# GRUNT/CREAK/CHIRP/SQUEAK NOISE FROM THE FRONT LOWER CONTROL ARM OVER BUMPS

TSB 13-7-8

**FORD:**  
2011-2014 Mustang

The article supersedes TSB **12-8-24** to update the model years, Service Procedure and Part List.

Figure 1 - Article 13-7-8

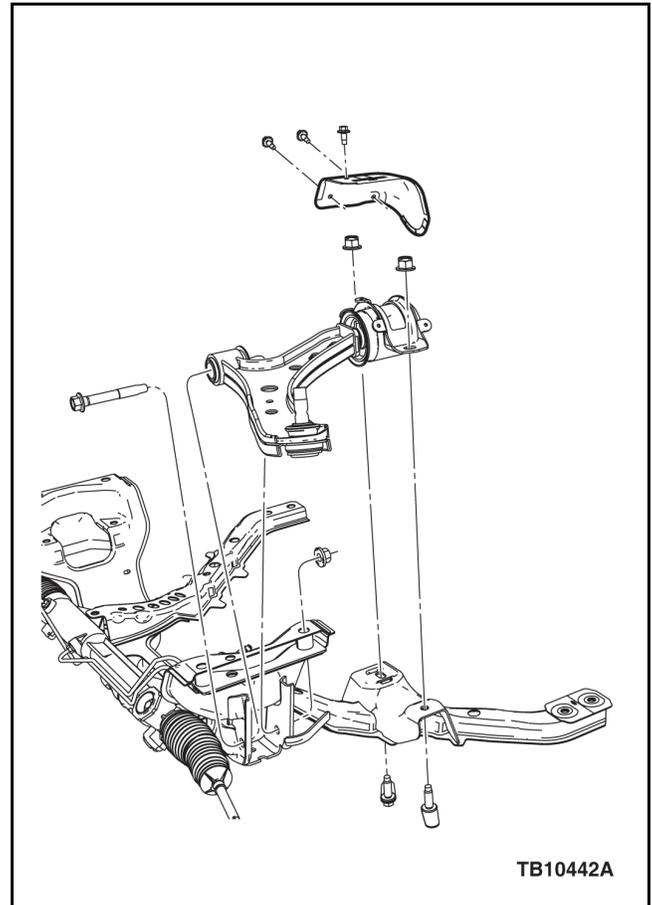
1. Attach Rotunda wireless chassis ears (JSP97202) or equivalent on both lower control arm hydro bushing bracket tabs to verify noise is coming from the hydro bushing.
  - a. The hydro bushing is the large diameter bushing at the rear of the control arm. Due to hydraulic fluid flow some noise from the bushing is normal. There would typically be some difference from side to side on a unit with a noisy control arm.
2. If the noise is not confirmed as coming from the hydro bushing, this article does not apply, refer to Workshop Manual (WSM), Section 204-00 for normal diagnostics.
3. If the noise is confirmed as coming from the hydro bushing, replace the affected lower control arm with the new lower control arm with shield and 3 screws. Tighten the three (3) shield screws to 7 N•m (62 lb-in.) Refer to WSM, Section 204-01. (Figure 1)
